Parking Brake Improvement

The bolts for the parking brake can come loose and create premature wear on the rim.

KWO453090

This instruction is applicable on RH and LH side. The illustration shows the LH side.

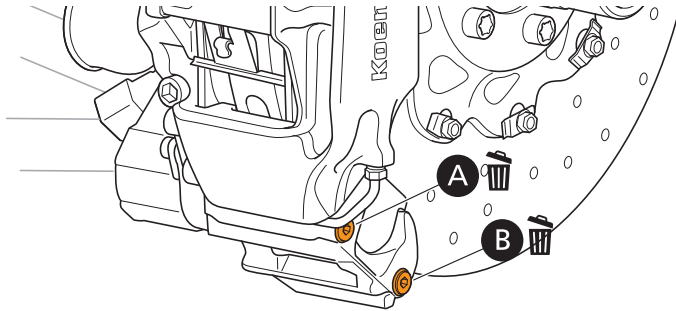
Replace the bolts with the new ones and apply thread locker.

If the bolts that attach the parking brake are not correctly torqued with threadlocker, the parking brake can get loose and cause an accident.

1. Do a check of the LH and RH parking brake calipers to make sure that there are no scratches or other damages.
 - 1.1 If you find a scratch or other damages, submit a KATS ticket to contact Koenigsegg.
 - 1.2 If there are no damages on the parking brakes, continue with the next step.
2. Do a check of the inner side of the LH and RH rear rim spokes. Make sure that there are no scratches or other damages that are caused by the parking brake.
 - 2.1 If you find a scratch or other damages, submit a KATS ticket to contact Koenigsegg.
 - 2.2 If there are no damages on the rear rim spokes, continue with the next step.
3. Remove and discard the H6 bolt **A** from the parking brake caliper.

4. Install the new H6 bolt to the parking brake caliper.
Part: 130-174-0553
Threadlocker: Loctite 270
Torque: 10 Nm
5. Remove and discard the H6 bolt **B** from the parking brake caliper.
6. Install the new H6 bolt to the parking brake caliper.
Part: 130-174-0553
Threadlocker: Loctite 270
Torque: 10 Nm
7. Do steps **3** thru **6** on the other side of the vehicle.
